STRUCTURAL EVALUATION OF

LINCOLN ELEMENTARY SCHOOL

WEST CONTRA COSTA UNIFIED SCHOOL DISTRICT
(WCCUSD)

April 30, 2002

Figure 11: Concrete pedestal at classroom building covered walkway

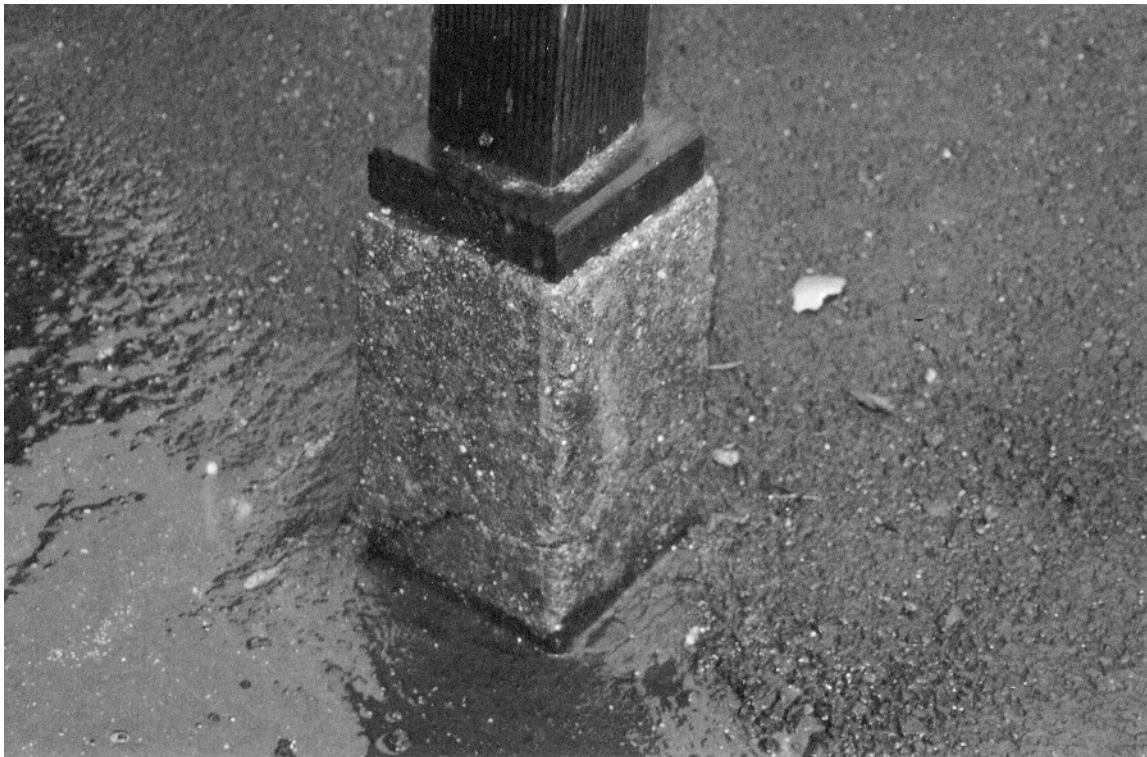
9.	At the covered walkway at the front of the classroom building, the posts rest on unreinforced concrete pedestals that could fall over and cause the post and supported roof framing to lose vertical support. Also, one of the pedestals has significant cracking, making the failure of the pedestal and subsequent partial collapse of the overhang during an earthquake more likely to occur.

5.	Add new plywood sheathing to the interior face of the wall. Provide new collectors as required. Add new holdowns at the ends of shear wall panels.	1.4	N/A
6.	Replace damaged wood and paint to protect from weather.	1.9	8
7.	Infill some windows with new framing and shear wall. Provide new collectors and holdowns as required.	1.3	10
8.	Replace damaged members, and paint to protect from weather	1.5	12
9.	Shore existing posts and replace concrete pedestals.	1.5	11
10.	Provide new flexible connection at conduit	1.9	13
